WPA Form 1- Request for Determination of Applicability
Massachusetts Wetlands Protection Act M.G.L. c. 131, §40

RE: Request for Determination of Applicability (RDA) / Athletic Field-Synthetic Turf
12 Huttleston Avenue, Fairhaven, MA.

Re: **Response to Comments Letter Dated May 17, 2021**
RDA/Athletic Field-Synthetic Turf
Fairhaven, MA
(Pare Project No. 20211.00)

FIGURE 1 - FAIRHAVEN ATHLETIC IMPROVEMENTS NORTH SIDEWALK GRADING

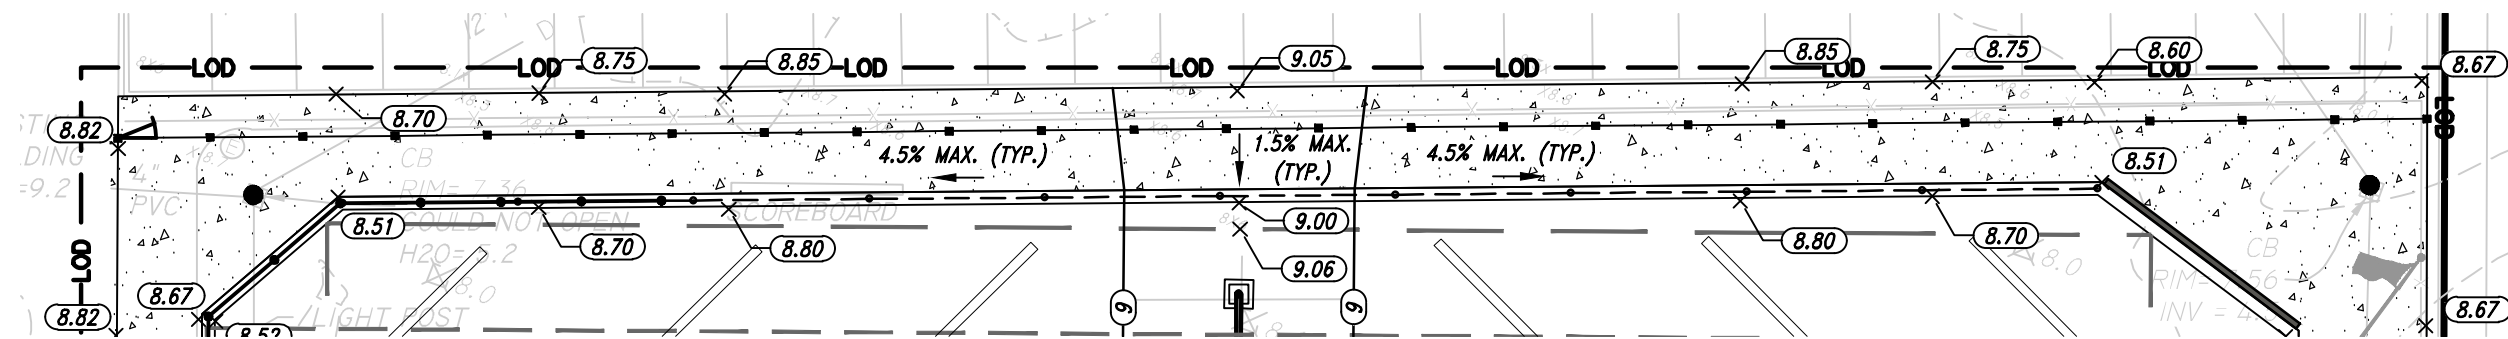
1. **COMMENT:** Add proposed spot grade at the northerly concrete walk to assure the walkway pitching toward athletic field. Existing and proposed spot grades, contours should be shown on the plan. The site is in Special Flood Hazard Areas, any filled area should be compensated with equal volume.

RESPONSE: *See Figure 1 attached showing spot elevations for northerly concrete walk. Note that the project plans include existing and proposed spot elevations and contours. The project limit of disturbance is located entirely outside of the Special Flood Hazard Area, and therefore no compensatory flood storage is required.*
